ADDENDUM NO. 1

Date: March 28, 2018

Project: Earl Warren, John Bidwell and Tahoe ES Irrigation Improvements

SHEET NO.
L1.4B
SHEET 13 OF 35

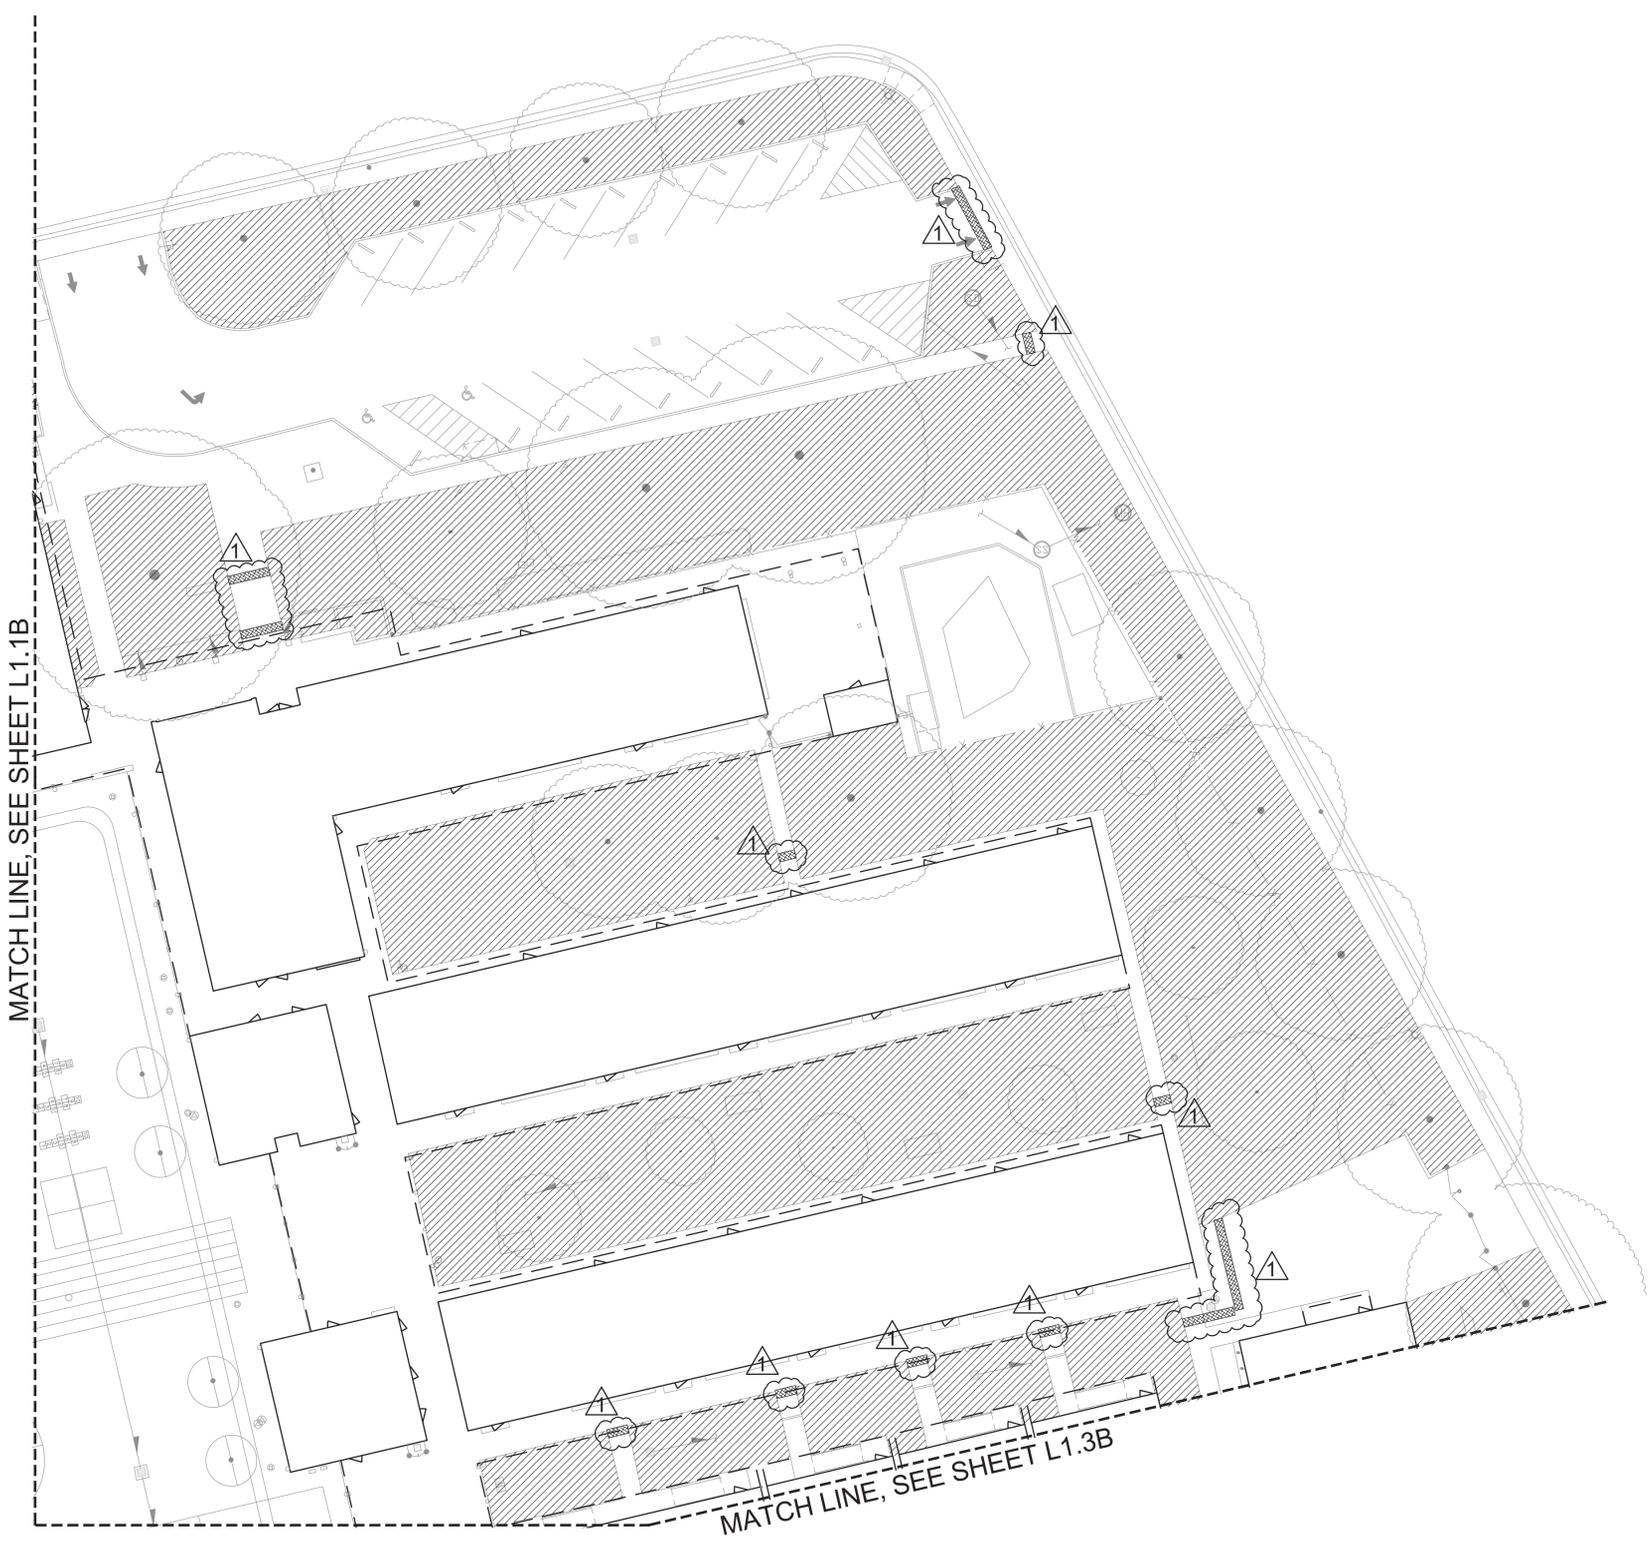
- d. Added grounding rod assembly symbol to legend.
 - e. Added a point of connection for valves #26-27, and renumbered valves #26, 27, 29.
7. DRAWINGS – L1.1B, L1.2B, L1.3B, L1.4B

- a. Added locations for asphalt/concrete saw cutting for new piping.
 - b. Note revised to ‘place’ aggregate.
 - c. Revised total sheet number count.
8. DRAWING – L2.1B

SHEET NO.
L2.3B
SHEET 16 OF 35

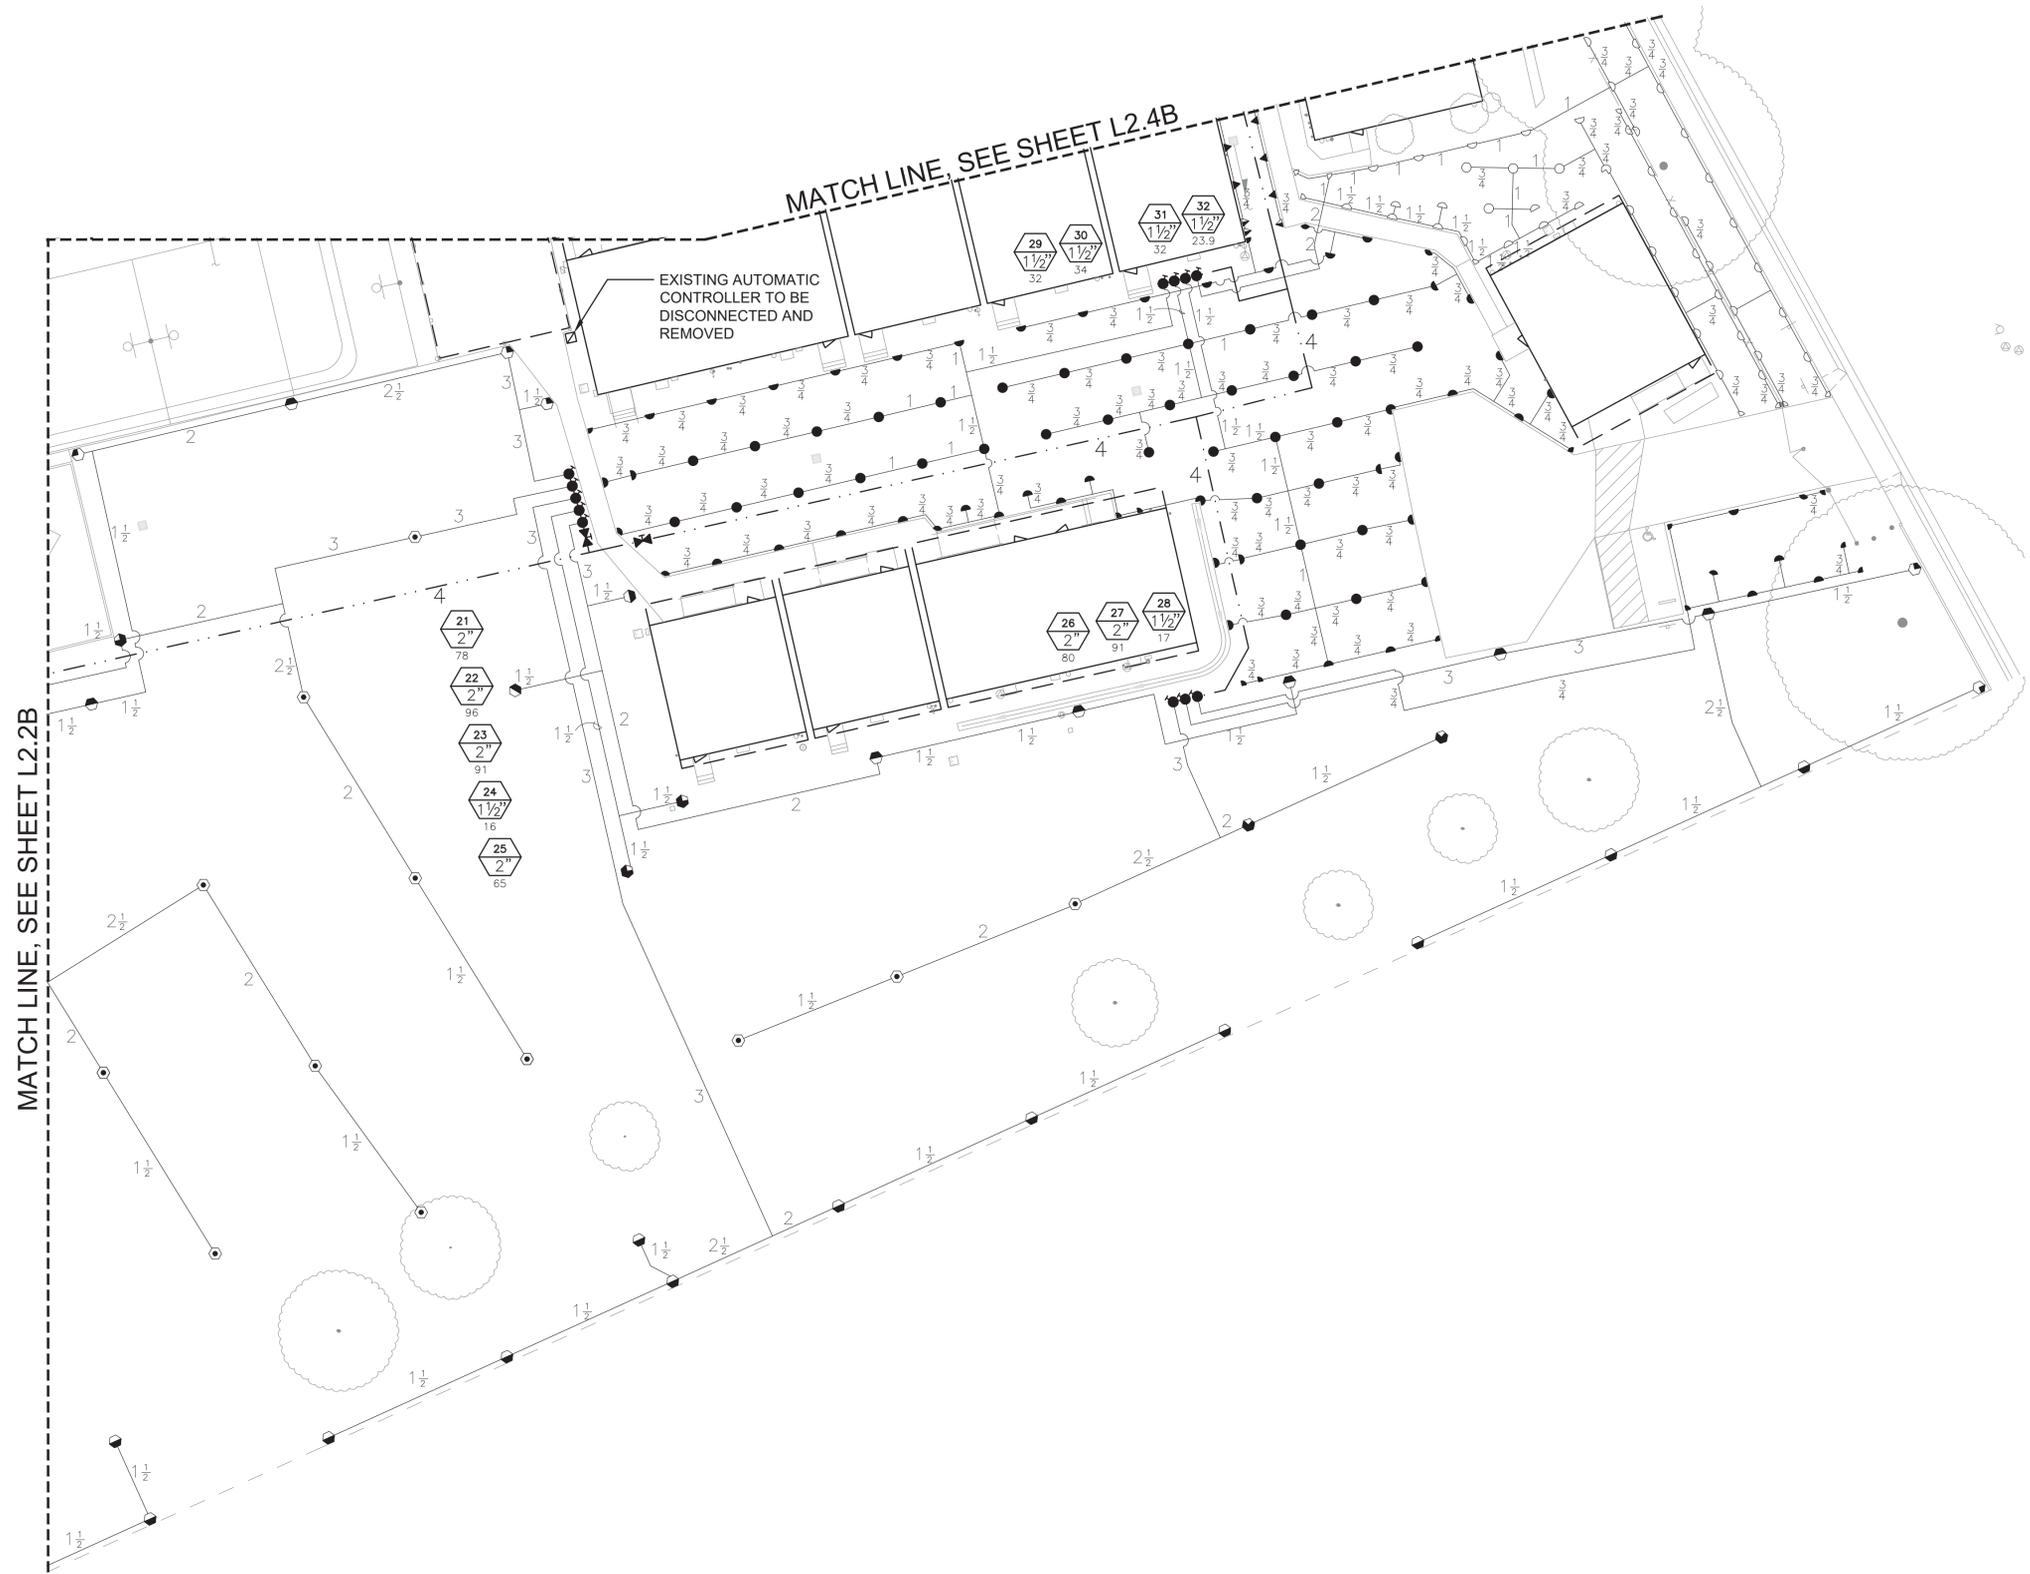
- e. Revised irrigation mainline pipe material in legend.
 - f. Revised total sheet number count.
9. DRAWINGS – L2.2B, L2.3B
- a. Revised total sheet number count.

6 CAST-IN-PLACE CONCRETE PAVING

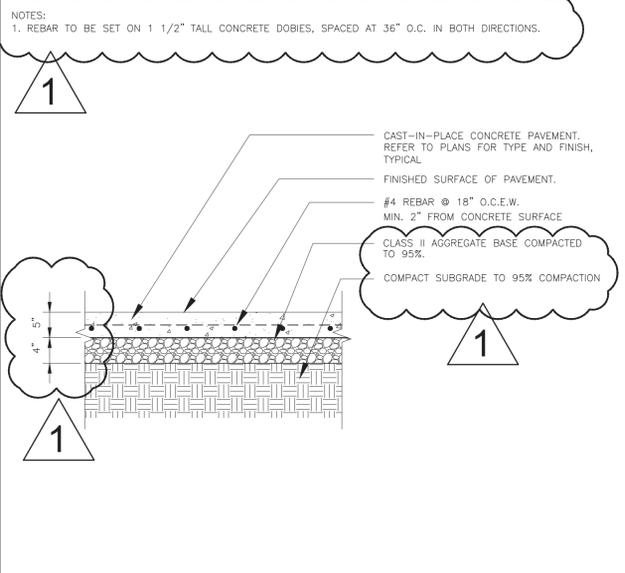
- a. Revised detail #6 to clarify compacted aggregate, subgrade compaction, concrete and compacted aggregate depth, and the use of concrete dobies to elevate the rebar.
- b. Added detail #9 for valve box locations in shrub beds. This was in response to an RFI.
